# Access Compliance Report

## Public Rights-of-Way

### (Curb Ramps)

Intersection ID: N/A	Main Street: CRESSWIND BV	Cross Street: SHOFF CIR	Location: NW
ADA ID: 04CEC6C9EE2E	Ramp Type: Perp	Initial Pass/Fail: Pass	Overall Compliance: No
			Severity Score: 15.25

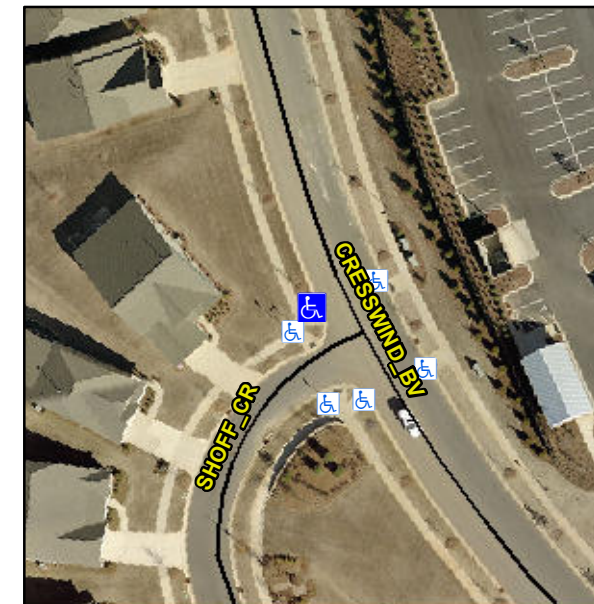
**Remove & Replace Detectable Warning System. Grind Gutter Lip.**

**R305.2, R302.7.2**
